=LT1 power unit SA2 Plus

Improvement of Bonding on SA2 Plus		Förster Technik GmbH		Zeichnungs-Nr. SK10071		Blatt	
						gezeichnet		Datum 28.02.2002		Gültig ab: 28.02.2002	
Änderung				Ind. Datum Name		Name		Gültig bis:		von Blätter

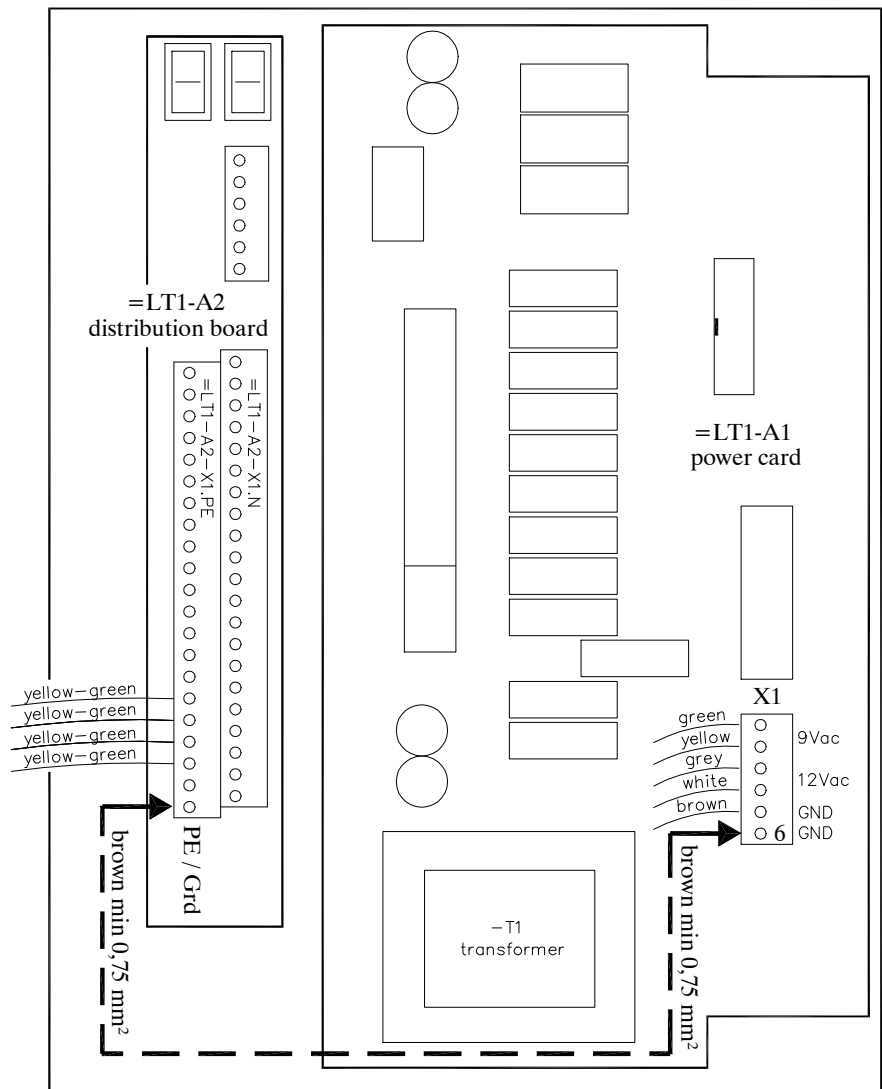
in case of problems with the electrode in the mixer jar  
(the liquid in the mixer jar overflows resp. there is lack of water),  
install an additional bonding point!
